# Illinois Department of Transportation

SUBJECT: Vermilion Regional Airport  
Danville, Illinois  
Vermilion County  
Illinois Project Number: DNV-5169  
AIP Project Number: 3-17-SBGP-TBD  
Contract No. VE059  
Item No. 05A, April 25, 2025 Letting  
Addendum A

## NOTICE TO PROSPECTIVE BIDDERS

Reason for Addendum:  
Revisions to the Plans

SHEET TITLE  
**CROSS SECTION  
INDEX**

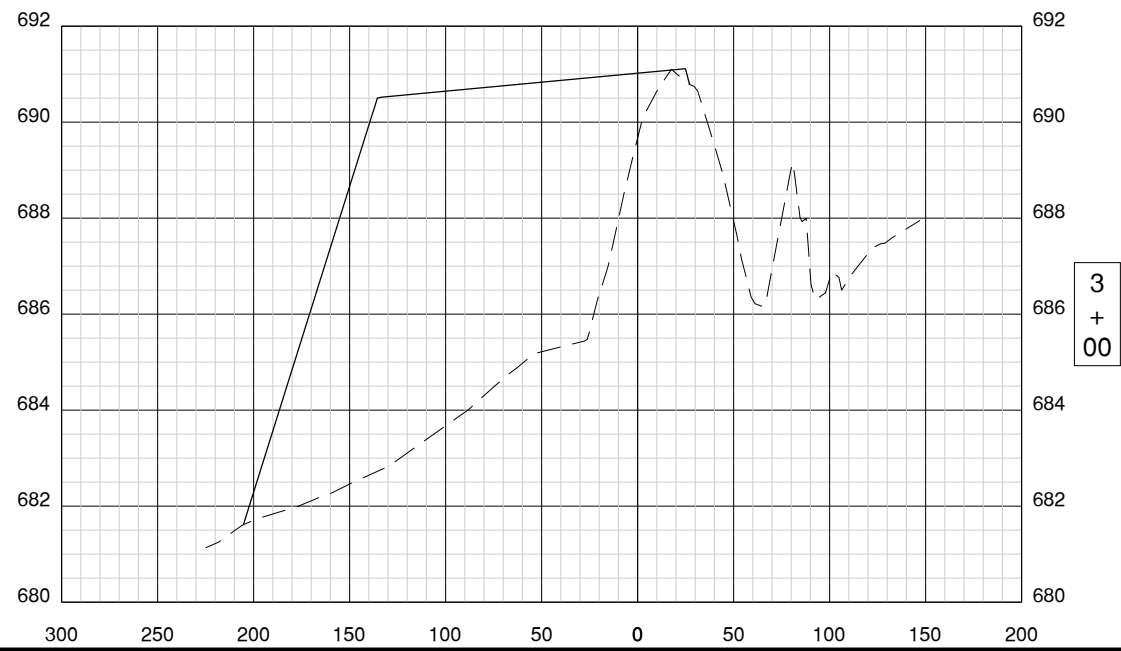
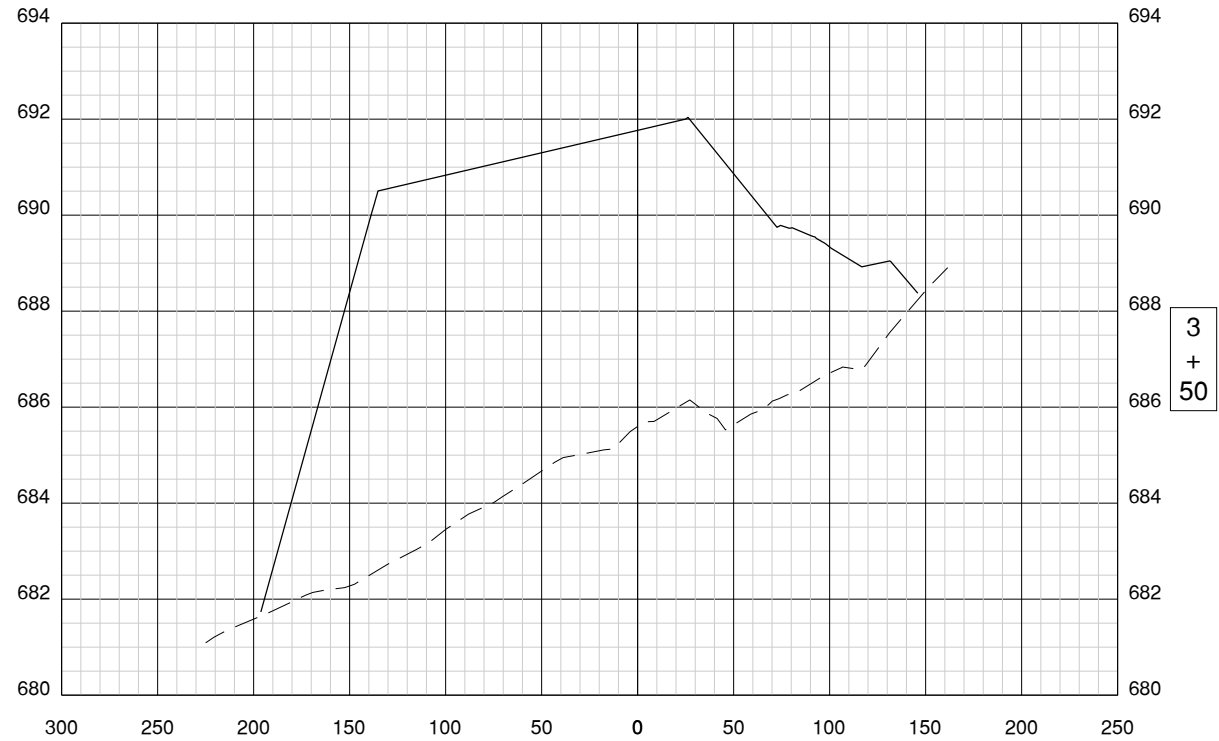
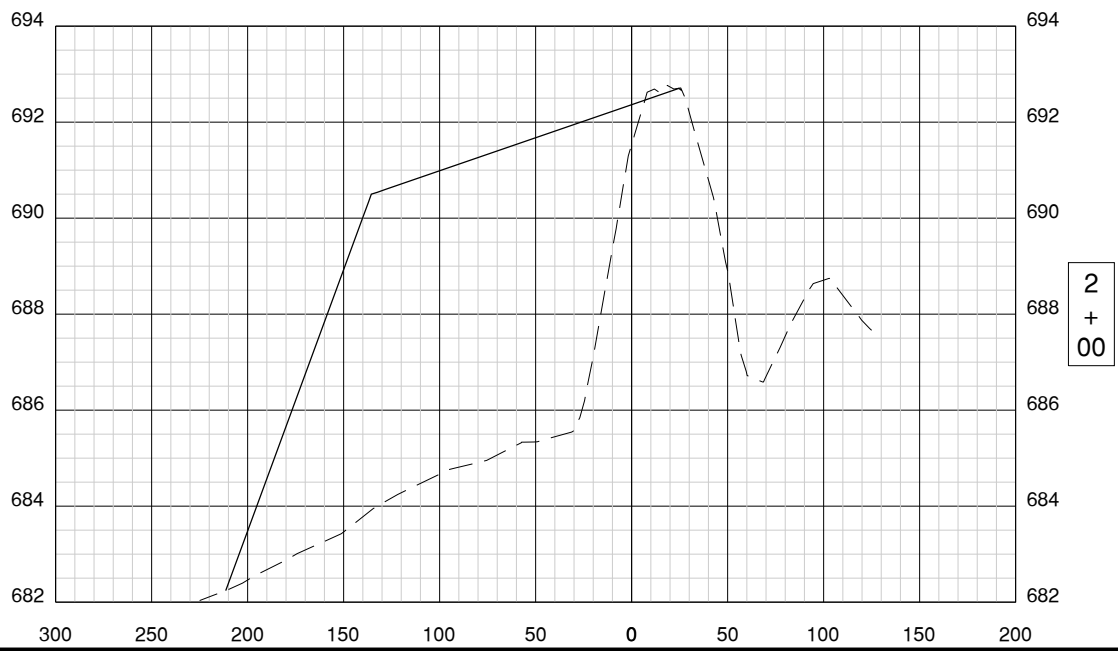
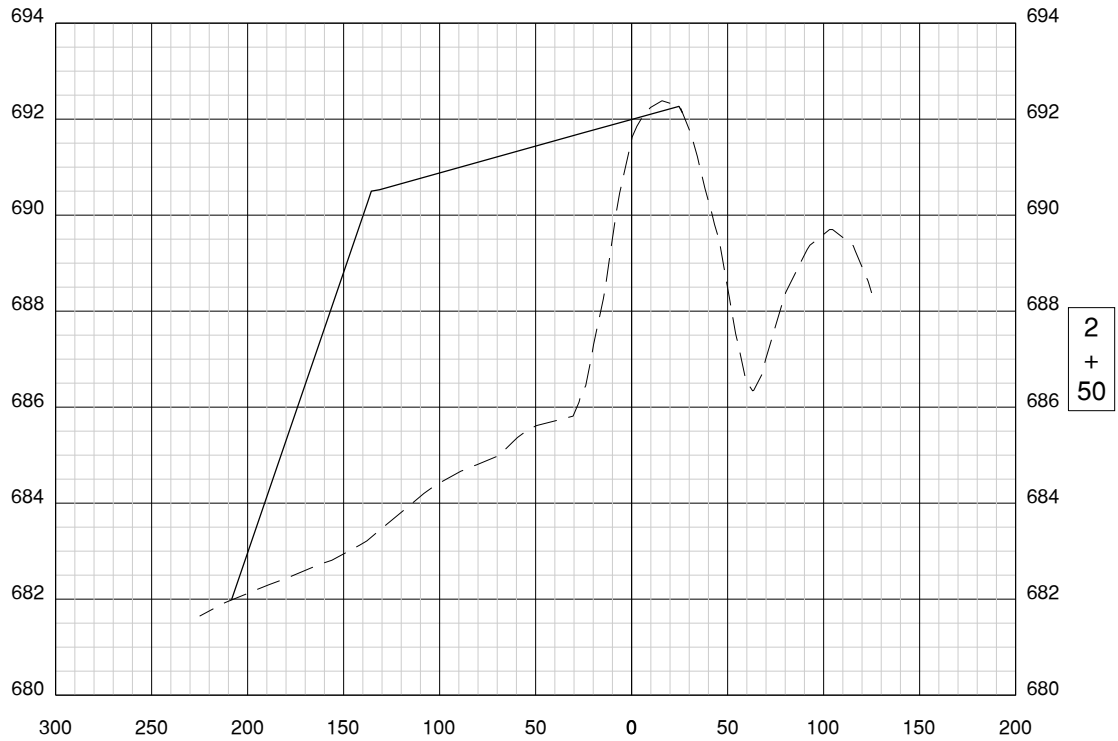
1. SHEET 50  
REVISE:  
Station labels STA 517+01, STA 518+01, & STA 519+01 to be STA 517+00, STA 518+00, & STA 519+00 respectively.

ADD:  
Earthwork Summary Table showing cut and fill quantities.

Note that the fill quantity for the Stockpile Cross Sections is not included, since the stockpile does not need to be constructed to the exact line and grade shown on the plans; rather, the stockpile is intended to be constructed with the excavated subgrade from the Taxiway and Turf Runway, since there is more cut than fill as shown in the Earthwork Summary Table for the Taxiway and Turf Runway. It will not be necessary to import material from offsite to construct the stockpile.

SHEET TITLE  
**PROPOSED  
STOCKPILE SECTION  
2**

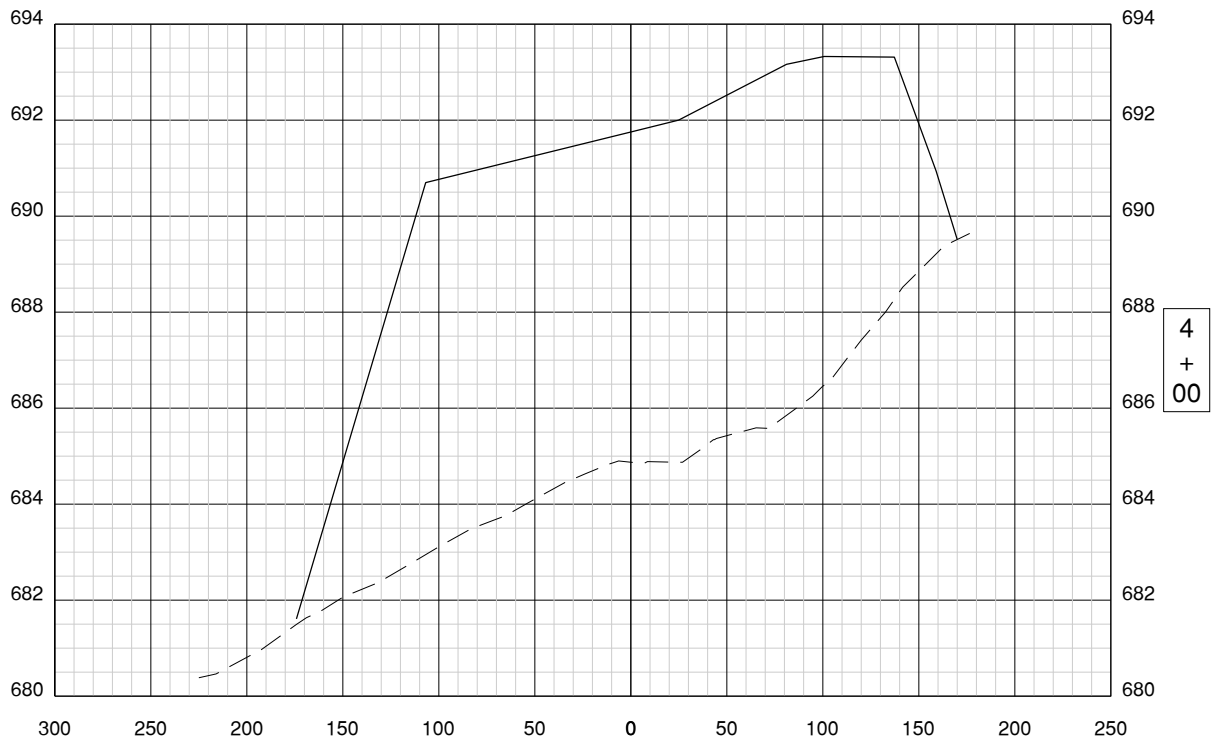
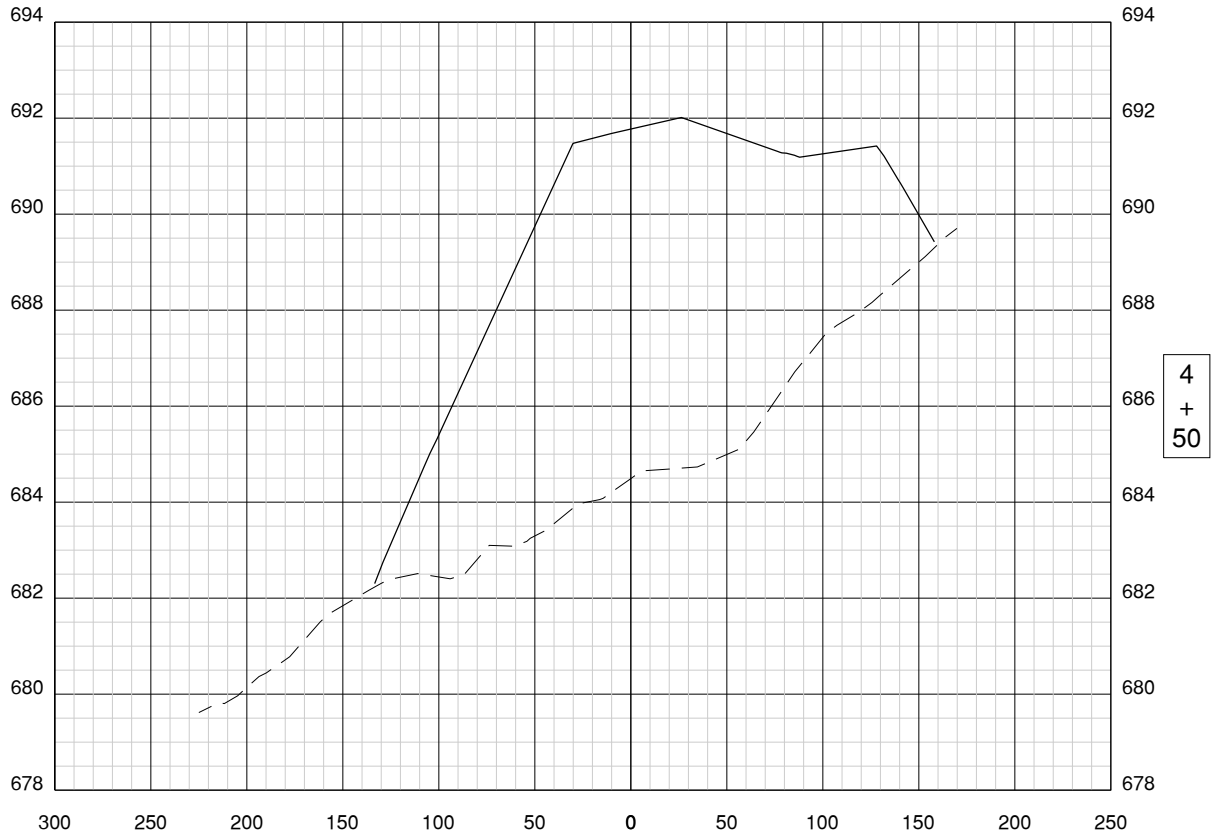
2. SHEET 60-62  
REVISE:  
Notes 1 & 2 as shown on the attached plan sheet
3. SHEET 63  
REMOVE:  
- Guardrail and pavement structure

1. UNCLASSIFIED EXCAVATION UNSUITABLE FOR EMBANKMENT OR IN EXCESS OF THE QUANTITY REQUIRED WILL BE STOCKPILED ONSITE AT THE DESIGNATED LOCATION, FOLLOWING THE GENERAL FOOTPRINT AND MAXIMUM SLOPES SHOWN IN THE PLANS.
2. THE CONTRACTOR SHALL FOLLOW THE BENCHING METHOD DETAILED ON SHEET CG633 FOR MATERIAL PLACEMENT.

PROPOSED  
STOCKPILE DETAIL

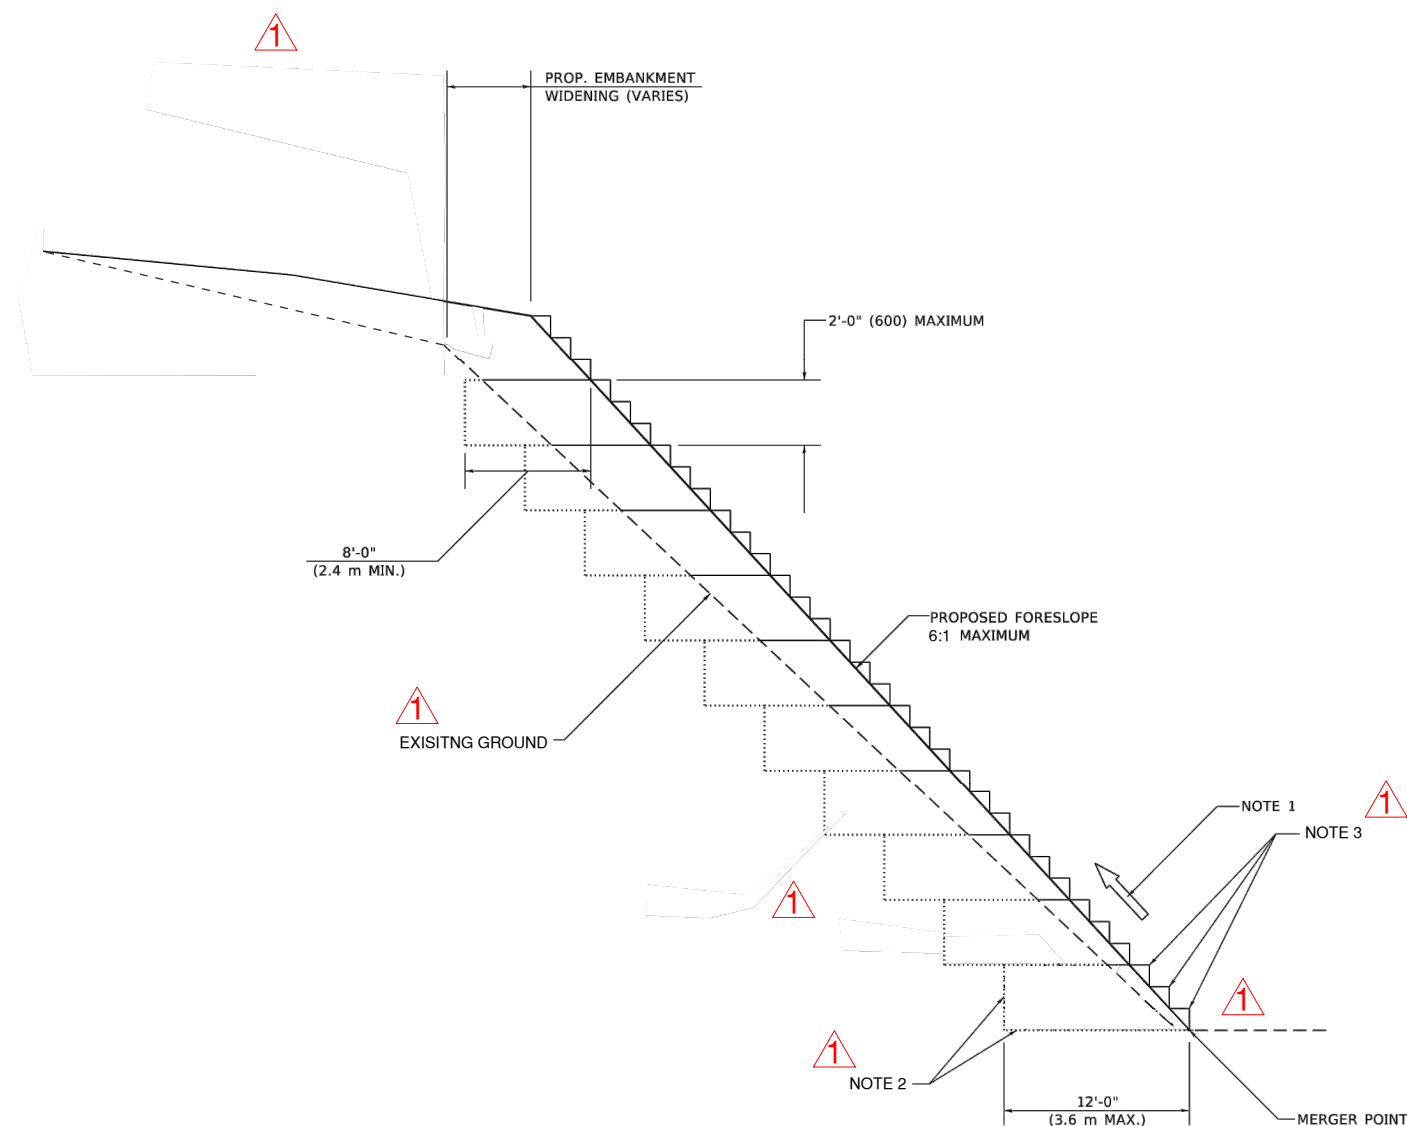
REVISE:

Notes and Callouts as shown on the attached plan sheets.

- all callouts with text "NOTE 3" to be "NOTE 2"
- all callouts with text "NOTE 4" to be "NOTE 3"
